UNITED STATES PATENT AND TRADEMARK OFFICE

APPLICATION NO.	FILING DATE	FIRST NAMED INVENTOR	ATTORNEY DOCKET NO.	CONFIRMATION NO.
10/715,670	11/17/2003	Chiahua Ho	MXICP017	4806

Office Action Summary	Application No. 10/715,670	Applicant(s) HO, CHIAHUA	
	Examiner TRONG PHAN	Art Unit 2827

DETAILED ACTION

FIG. 4A

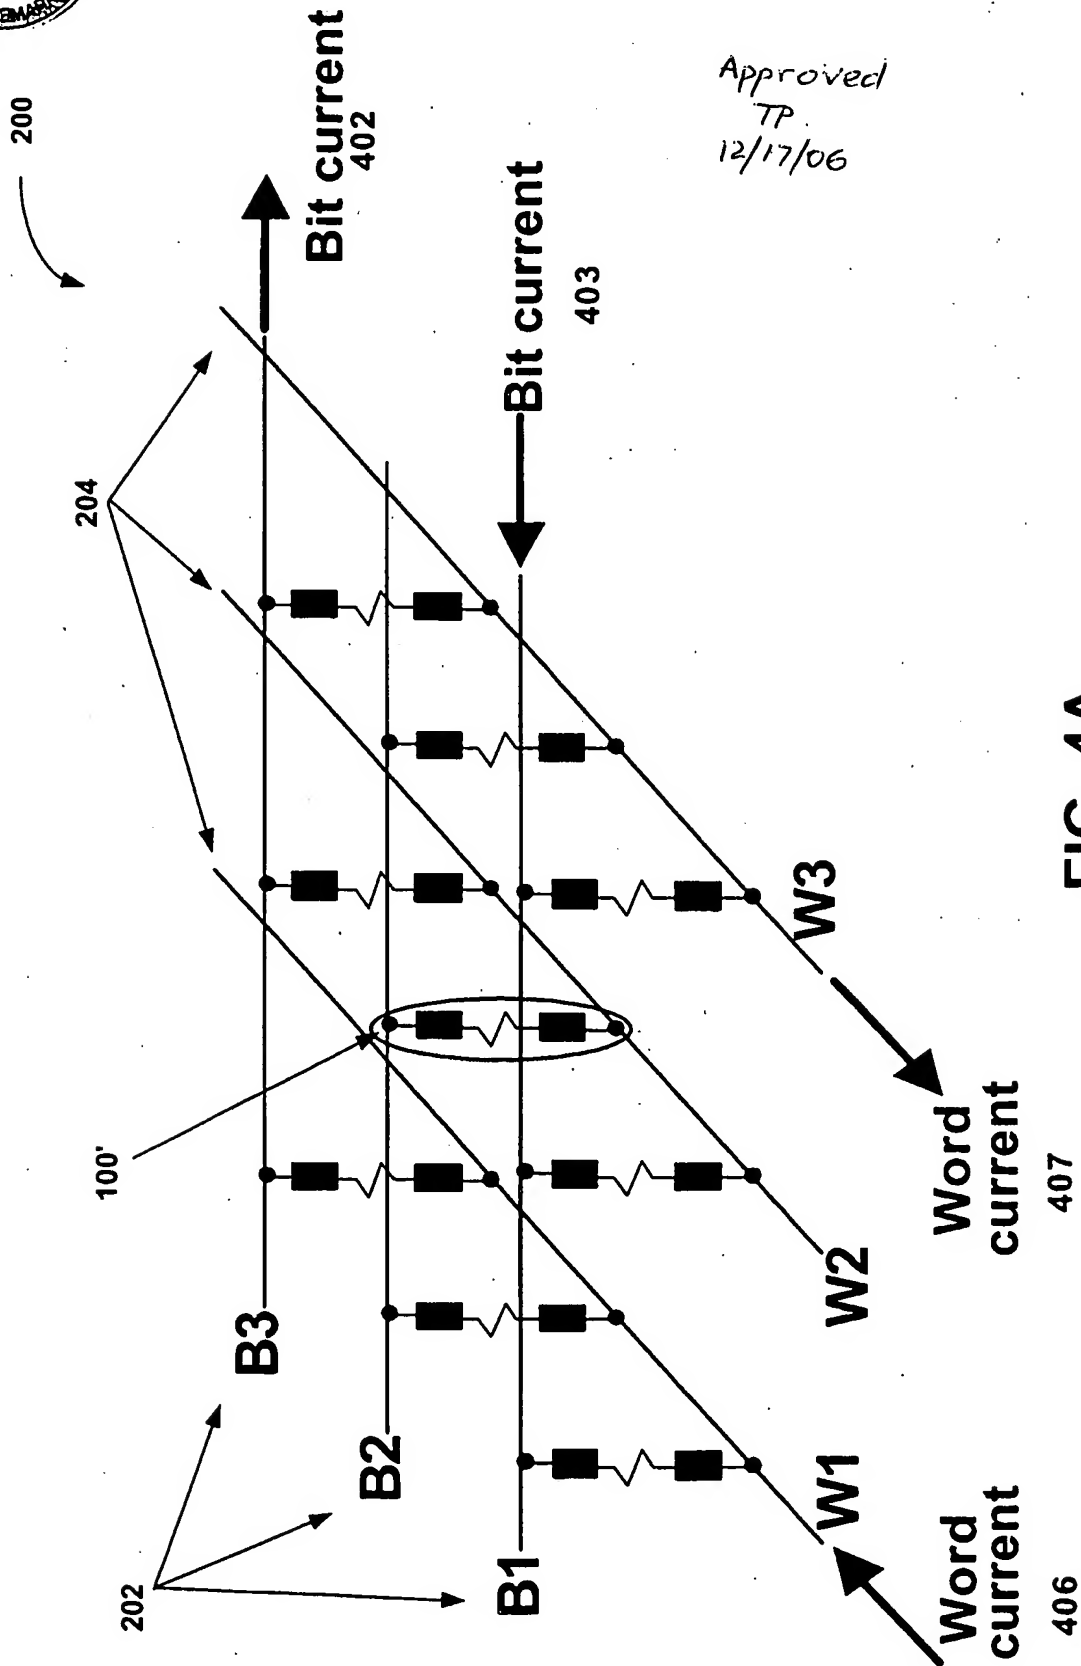
Regarding Fig. 4A, it is not understood how the method of programming the unit cell 100', which is coupled to bitline B2 and wordline W2 (see lines 1-3, page 8 of the original specification), to store a logic value 0 is not involved with anything to the directions of the currents placed on the bitline B2 and wordline W2.

Appropriate correction is required.

FIG. 4B

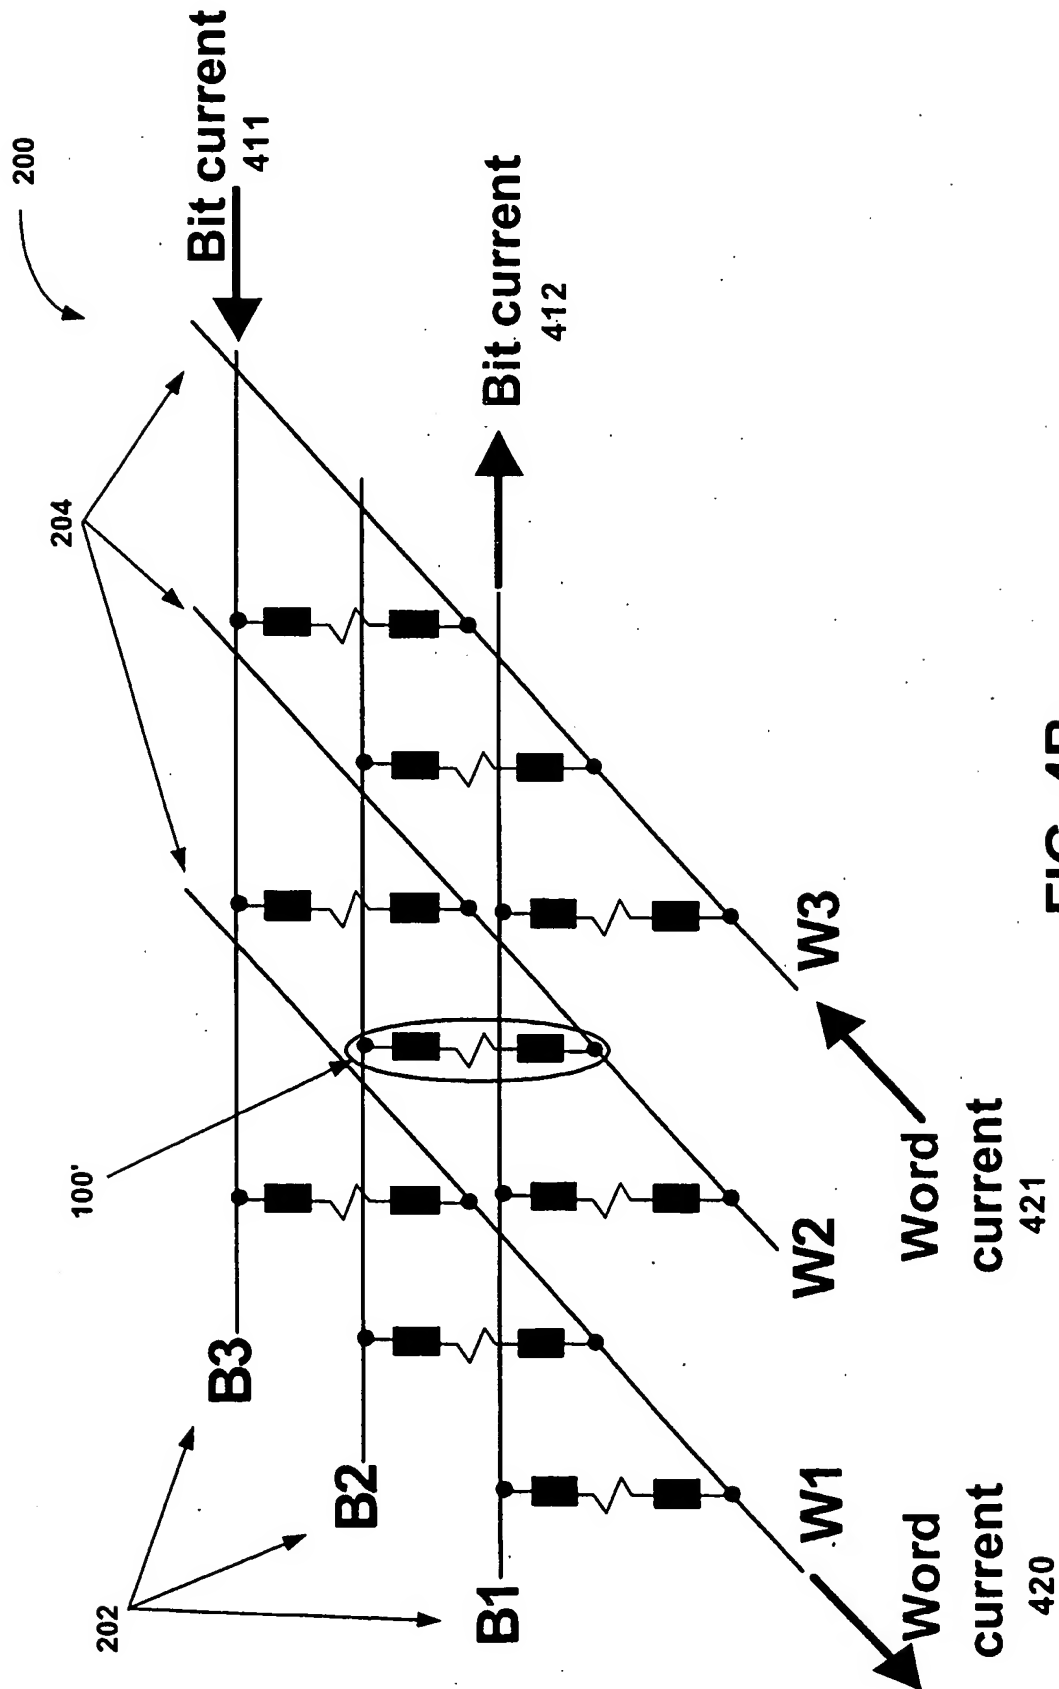
Regarding Fig. 4B, it is not understood how the method of programming the unit cell 100', which is coupled to bitline B2 and wordline W2 (see lines 1-3, page 8 of the original specification), to store a logic value 1 is not involved with anything to the directions of the currents placed on the bitline B2 and wordline W2.
